Staff Report

- 6 Remove existing five skylights and patch with same type of roofing which is v-crimp- #1008 Eaton Street- Daniel Acevedo (H11-01-1325) After the fact

Photo taken by Property Appraiser's office c1965; 1008 Eaton Street; built c1889;
Monroe County Library

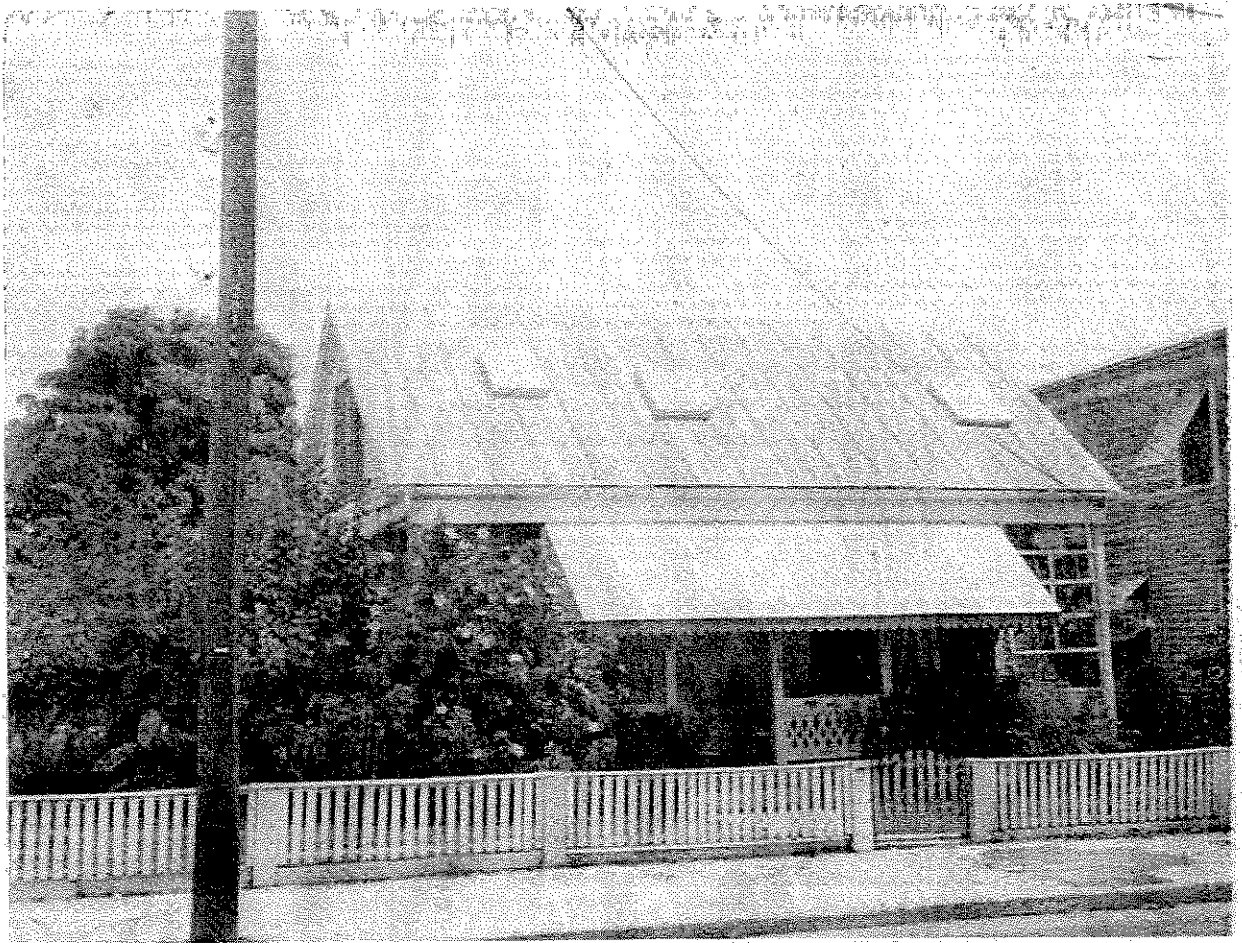
Staff verified that, at least the front gable roof used to have three scuttles. The aerial photo from Google earth of 2010 shows three scuttles on the front gable. As per today the roof has v-crimp, some of it looks new and the three scuttles that used to be part of the front gable roof have disappeared.
